UNLESS OTHERWISE SPECIFIED: DIMENSIONS ARE IN MILLIMETERS SURFACE FINISH: TOLERANCES: LINEAR: ANGULAR:				FINISH:	DEBUR AND BREAK SHARP EDGES	DO NOT SCALE DRAWING	REVISION
PROJECT NAME:				HRC:		SUBEC AB	
PROJECT NO:						TITLE:	
DRAWN Zitd				DATE 2019-02-25		Iris Guide Rolls, $\phi 10$ - $\phi 160$ mm Rollers $\phi 60$ L160, HRX	
MATERIAL:				ARTICLE NO:		DWG NO.	A3
				0065B		3-400313-04_0065B	
Q.A				WEIGHT:	g	SCALE:1:3	SHEET 1 OF 1 3-400313-04_0065B

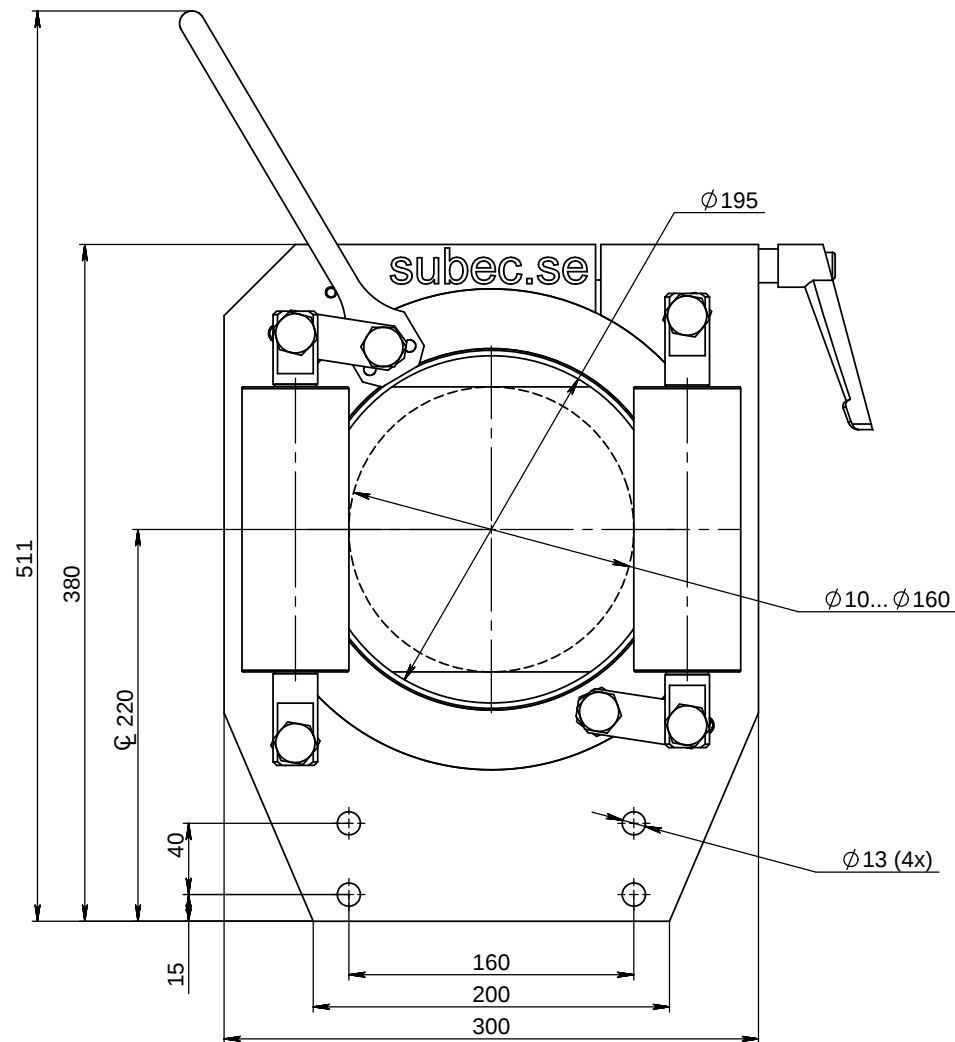
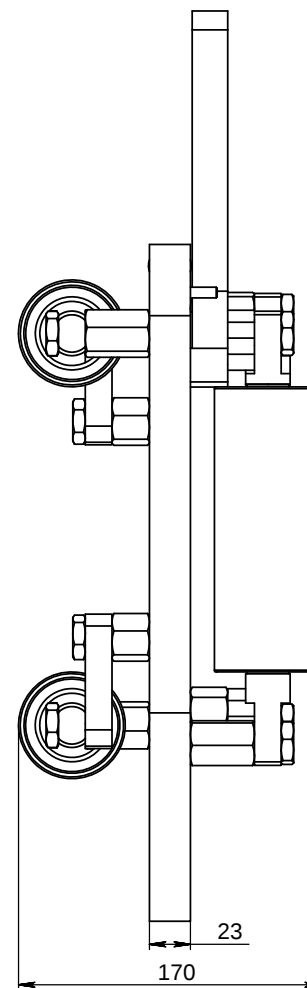
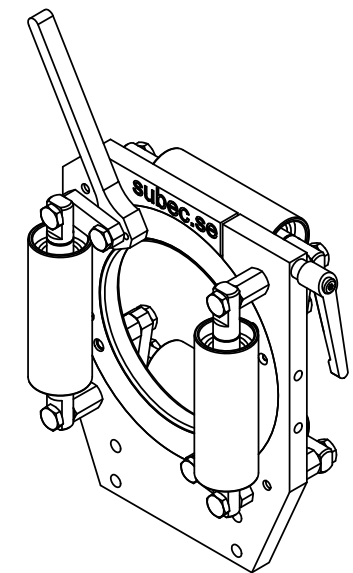
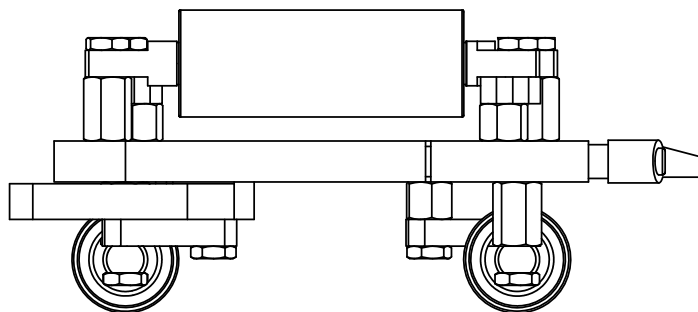
Revision B:

1. Changed Body # 0065BP1: 300x380; body cut for clamping hand (new clamping handle with total length 120mm); holes M12 on side for pneumatic holder
2. Changed inner Ring #0065BP3 to 3mm;
3. Changed flange thickness to 3mm for Traverss #0065BP2;
4. Changed shoulders #0065BP4 and 0065BP5
5. Changed shaft #0065BP8 for symetrical cylinder D60L160, made from h6 rod, shortened.
6. Changed height for joint plate #0065BP6, changed edge angle
7. Changed length for handlever # 0065BP9
8. Changed Ring on opposte side of Iris
